CITY OF WEST TORRENS

Notice of Panel Meeting

6.2.1 148 Anzac Highway, GLANDORE

Application No 22032260

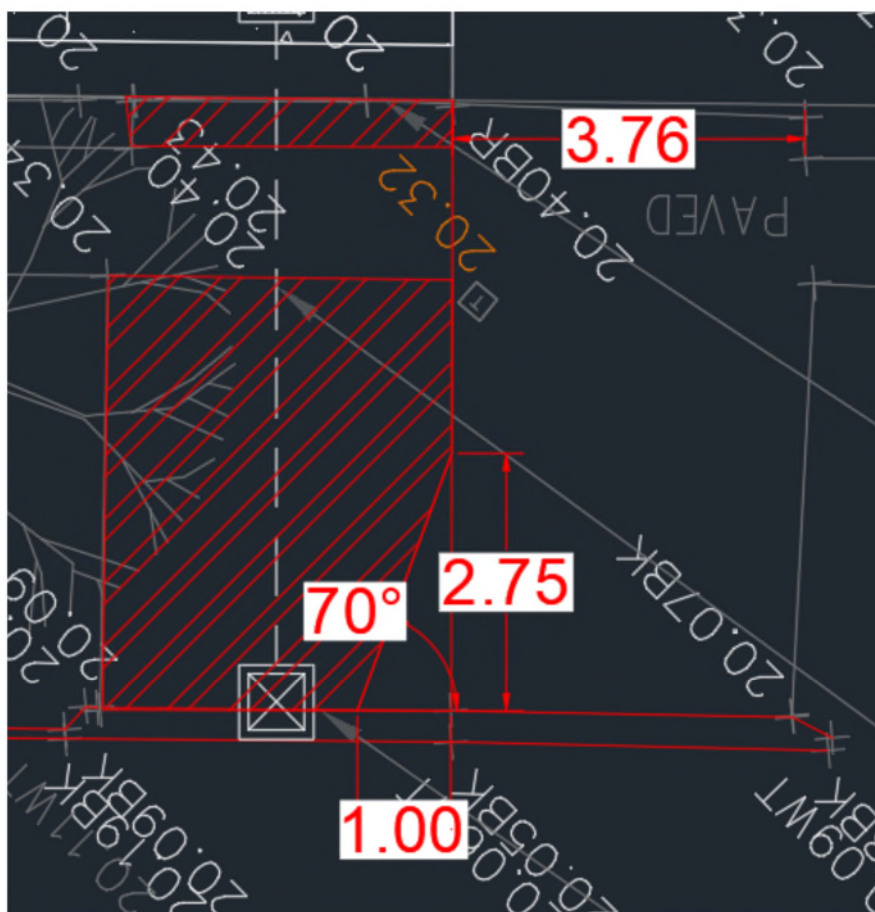
New driveways and stormwater connections are typically desired to be located a minimum 1.0 metre offset from other existing or proposed driveways, stormwater connections, stobie poles, street lights, side entry pits and pram ramps, etc. (as measured at the kerb line, except for driveway separation which will be measured from property boundary). An absolute minimum offset of 0.5m from new crossovers and stormwater connections to other existing road verge elements is acceptable in cases where space is limited.

These new features are also desired to be located a minimum of 2.0 metres from existing street trees, although a lesser offset may be acceptable in some circumstances. If an offset less than the desired 2.0 metres is proposed or if it is requested for the street tree to be removed, then assessment for the suitability of such will be necessary from Council's Technical Officer (Arboriculture).

- 2.1.1 No further assessment provided. Item still considered outstanding.** - A stobie pole is indicated to be removed in order to accommodate the crossover. Evidence must be provided to Council indicating that the appropriate authority (SAPN) has agreed to the

removal of the pole and that any relevant expenses are borne by the developer. Until such evidence is provided to Council, a crossover cannot be accommodated in the proposed area. A condition and the annotation on the resubmission of plans should be included that the existing stobie pole be relocated at the expense of the applicant.

Figure 7: Site Area (highlighted in red)

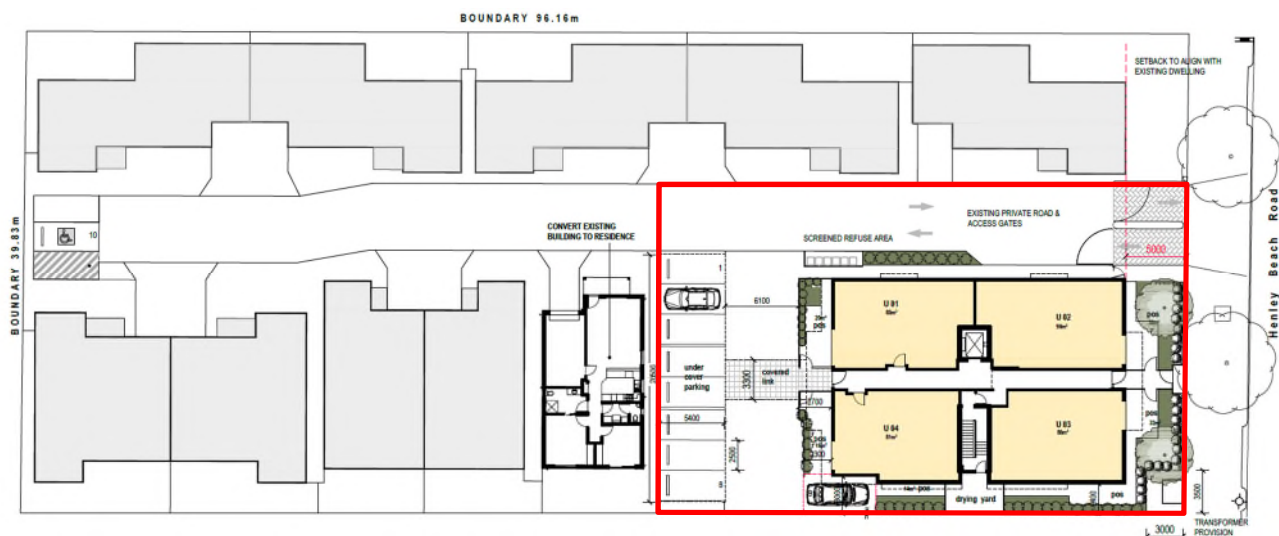
Based on this definition, the actual site of the proposed development is anticipated to include the footprint of the building as well as the associated private open space, car parks and a portion of the shared driveway (see Figure 7 below). Therefore, the site of the proposed development is considered to be in the order of 1,200m² which would equate to an average minimum site area per dwelling of 150m².

Figure 9: Line of Sight (Source: ADS Architects)

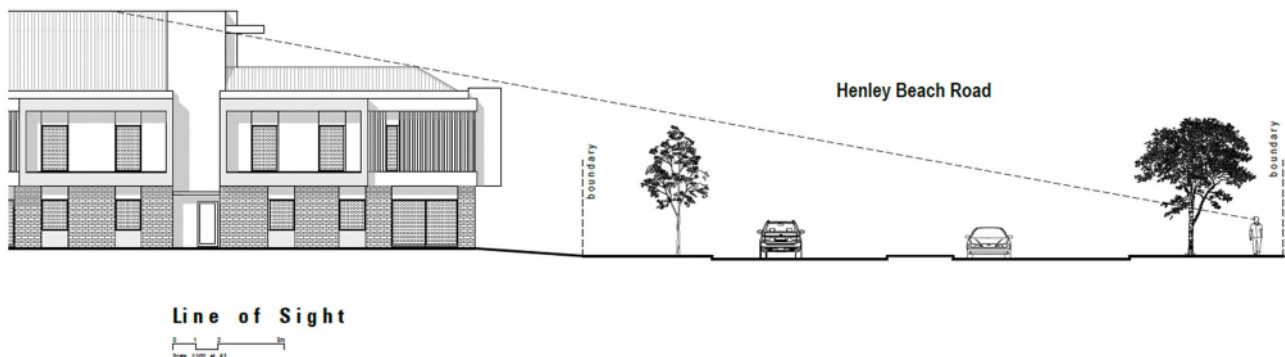
It is also noted that the third level will be setback approximately 12 metres from the front of the proposed building. In this way, the bulk of the building will be reduced when viewed from Henley Beach Road (and further south) thereby giving the impression of a two-storey building. This is illustrated in the 'Line of Sight' diagram prepared by the Applicant's Architects (see Figure 9). In addition, the height of the building will be comparable to the church on the adjoining site to the west.

It is noted that the three-storey element of the building will be sited approximately 17 metres from the residential properties to the east fronting Kenton Street. This separation distance will assist to reduce the visual impact of the proposed development from these properties (noting that the church is currently visible from these properties). However, the proposed development will create a visual impact on the first two existing single-storey dwellings located on the eastern portion of the subject land. More specifically, the eastern elevation of the proposed building will be quite imposing when viewed from the front yards and front rooms of the dwellings located along the eastern side of the subject land.
